Question from Kyle Kunka Sea West Enterprises, Inc. on Monday, Mar 10, 2025 at 03:12 PM PDT

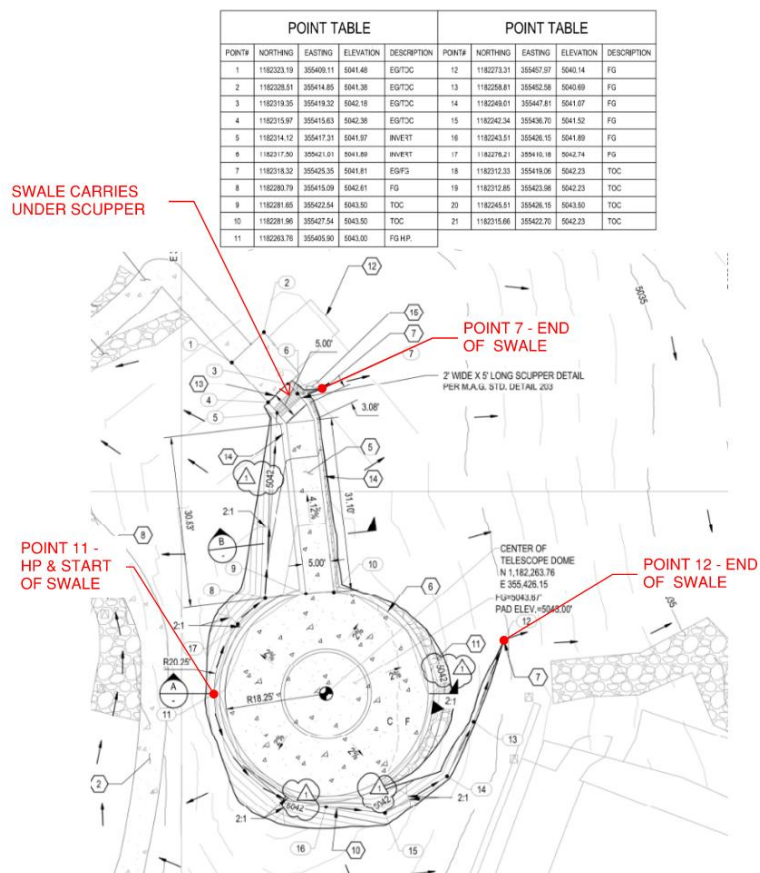
12. Please provide start & stop limits for Keynote 10/Detail 1, Section A & B. **Grecia, can you respond to this question?**

See figure below.
